project and code
Fraser House
36 Charlotte Street,
Manchester M1 4FD
2022-1008M

drawing title
Proposed GA Third Floor
Ceiling Plan

PLANNING ISSUE
drawing number / revision
2022-1008M - 046 C
scale
1:50 @ A1
04.07.2023
drawn / checked
CT / KS
0 0.5 1 2
Metres

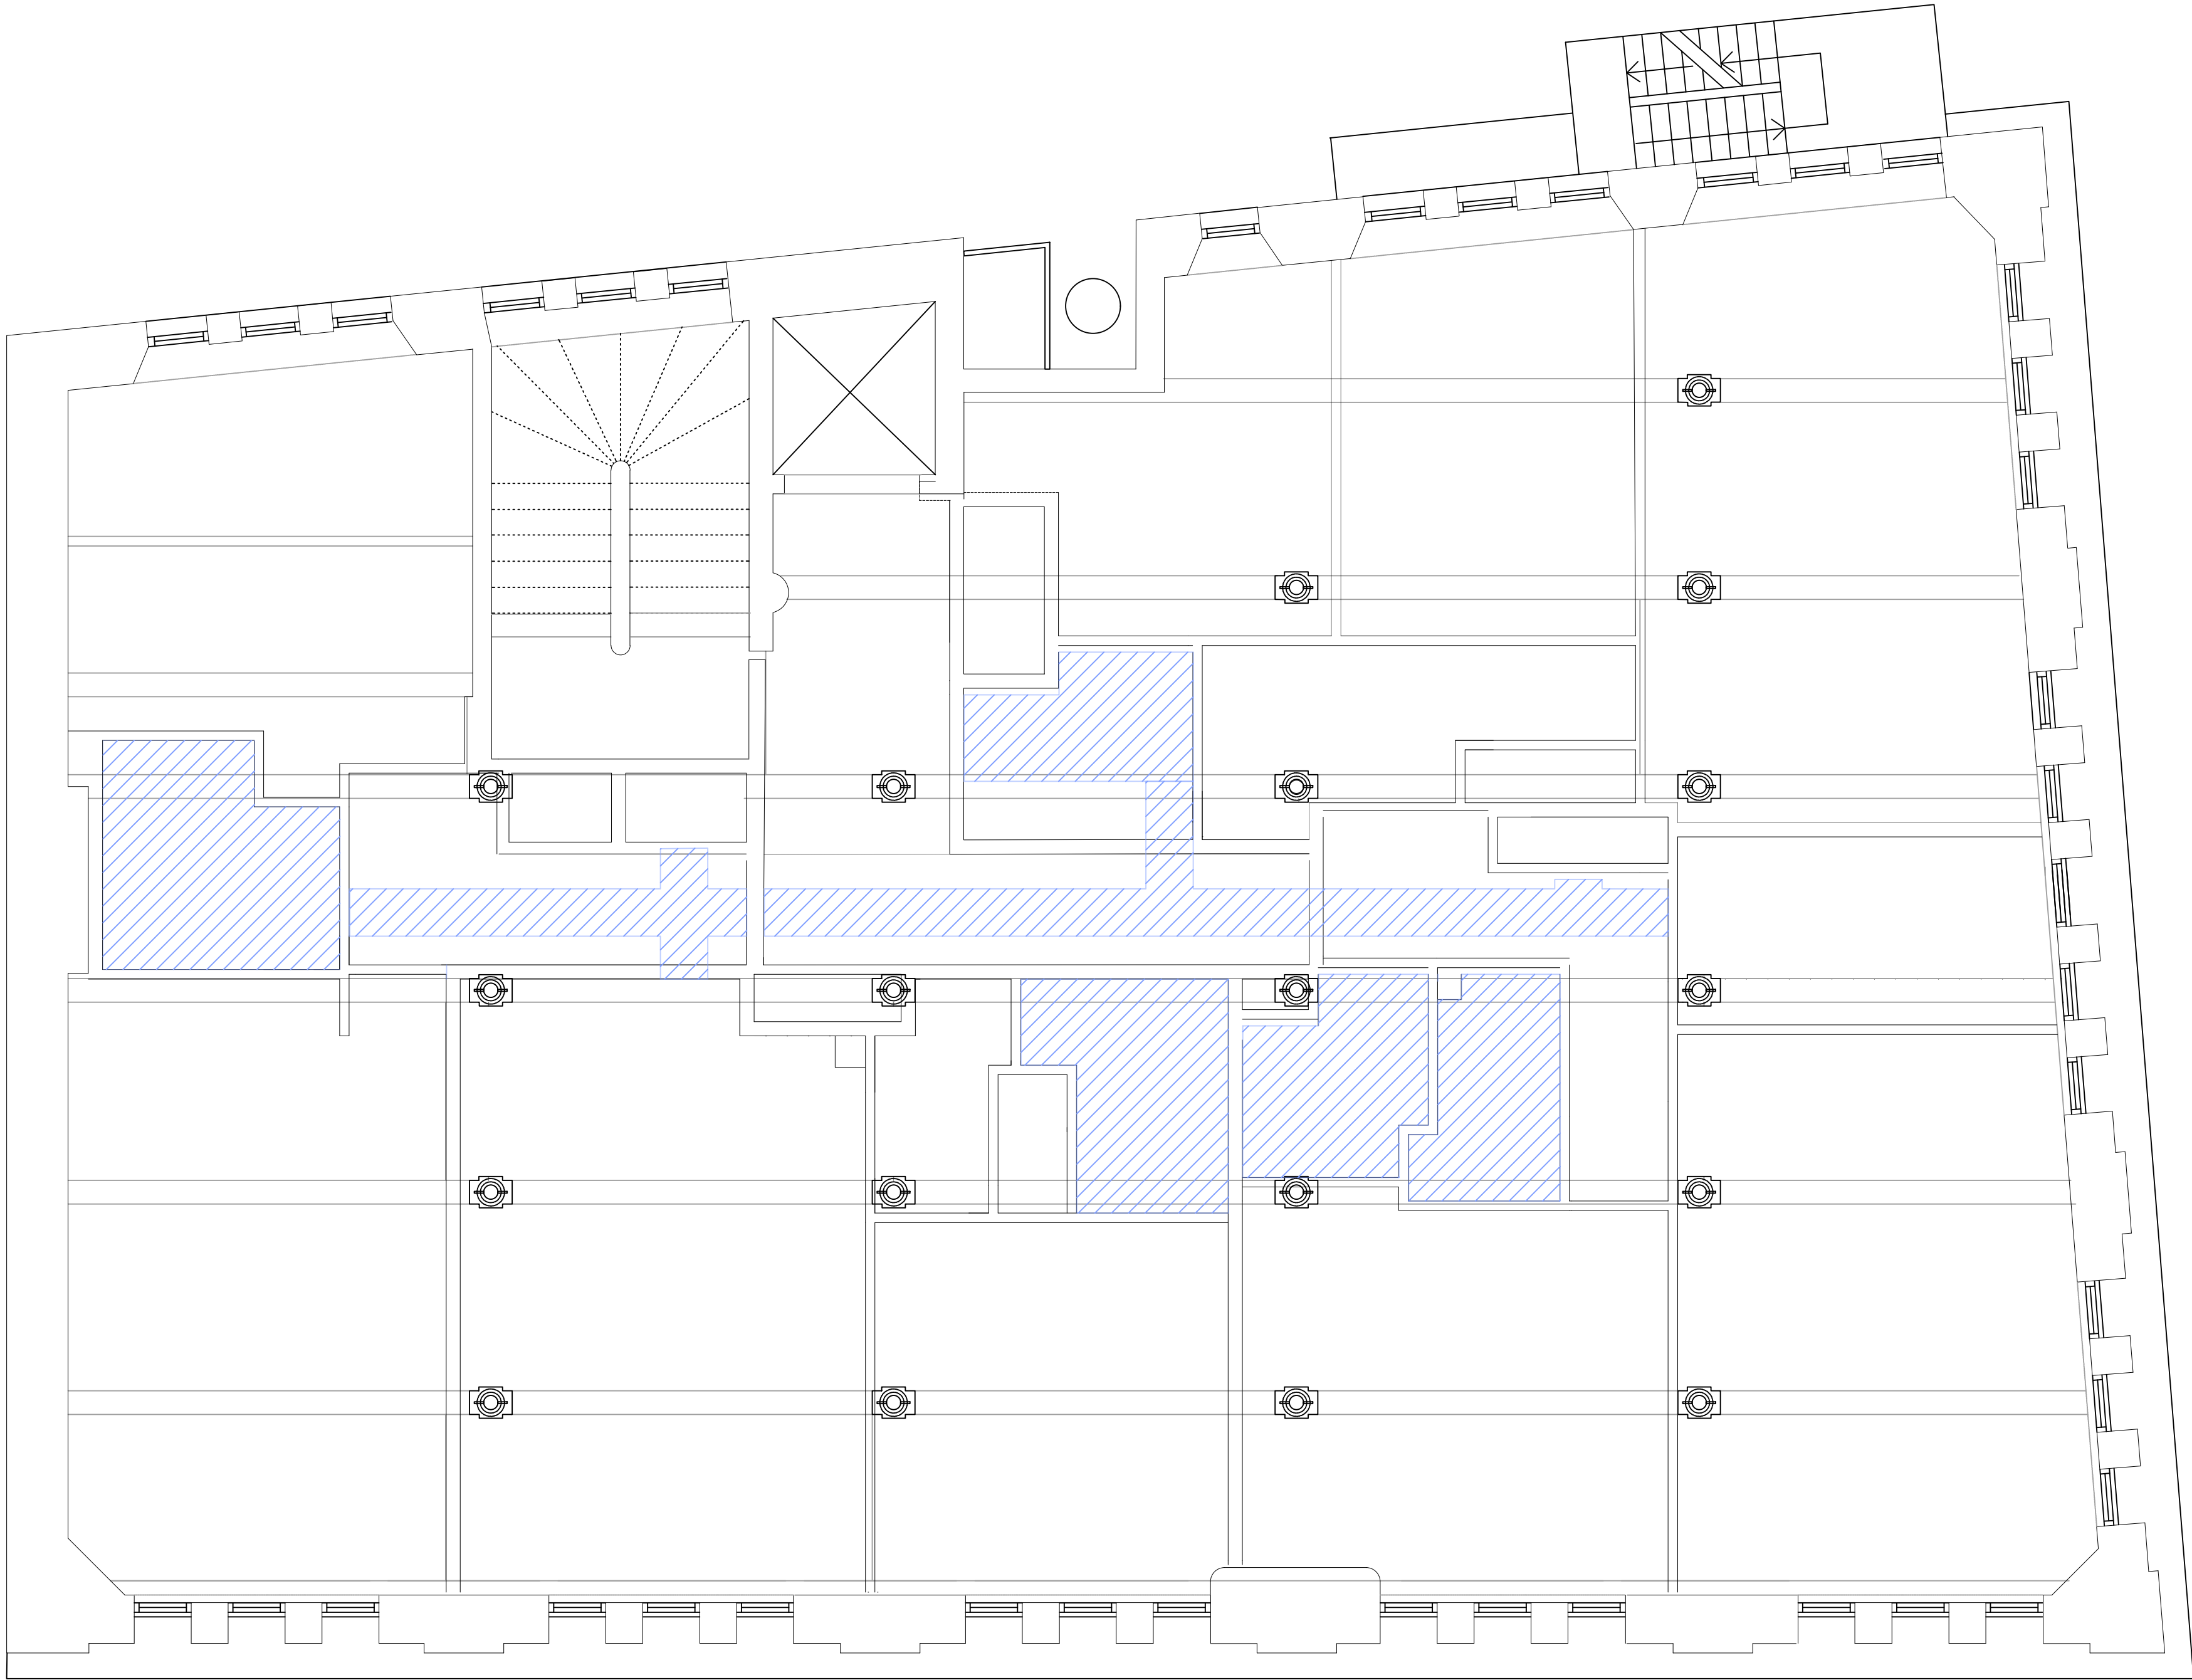
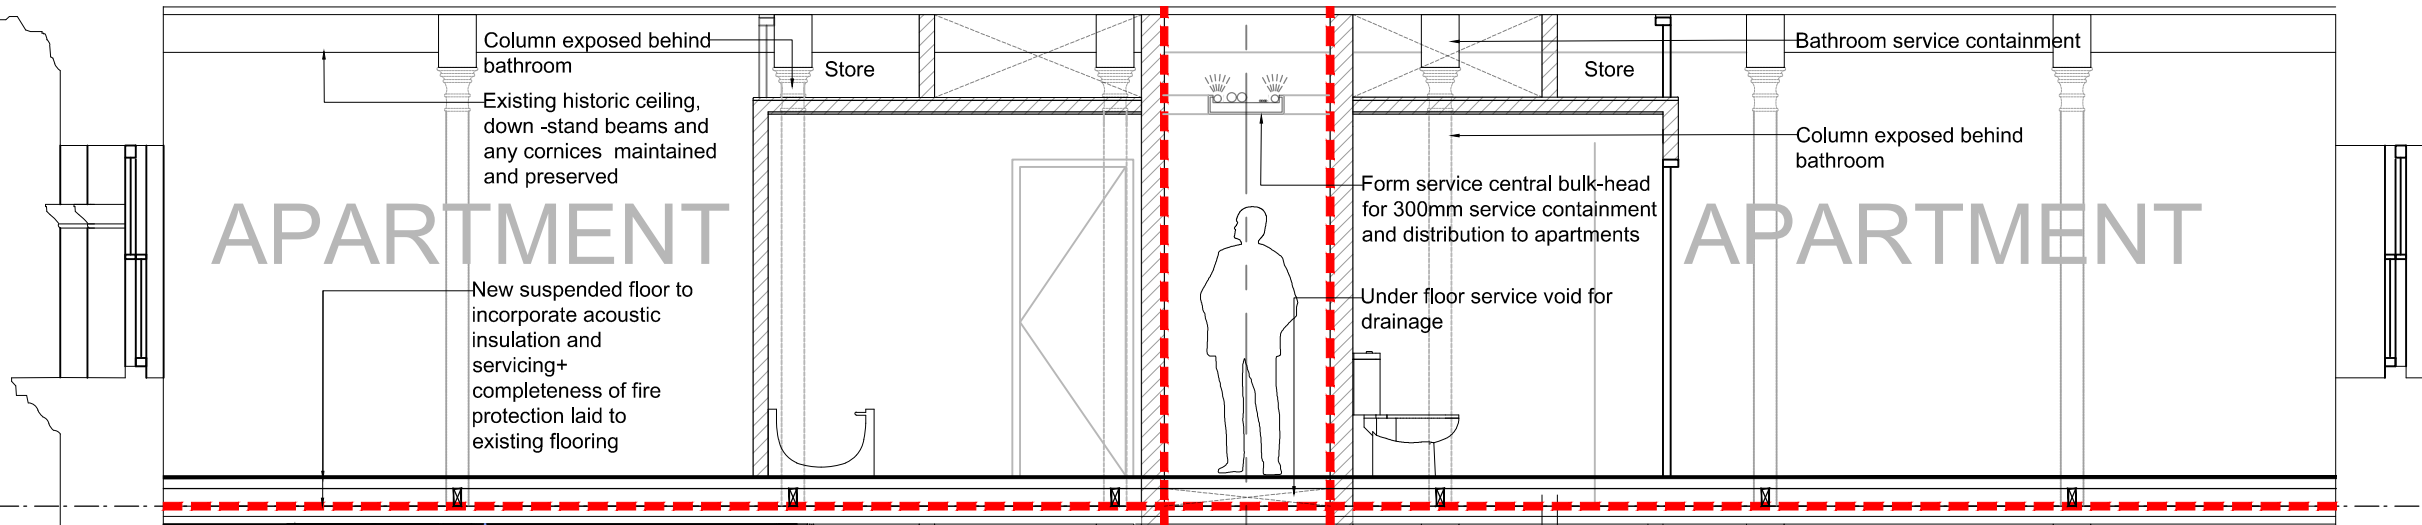
Revision C:
Drop ceiling has been reduced to only bathroom areas.
Suspended cable trays replaced drop ceilings in
corridor and communal areas for power distribution and
corridor lighting
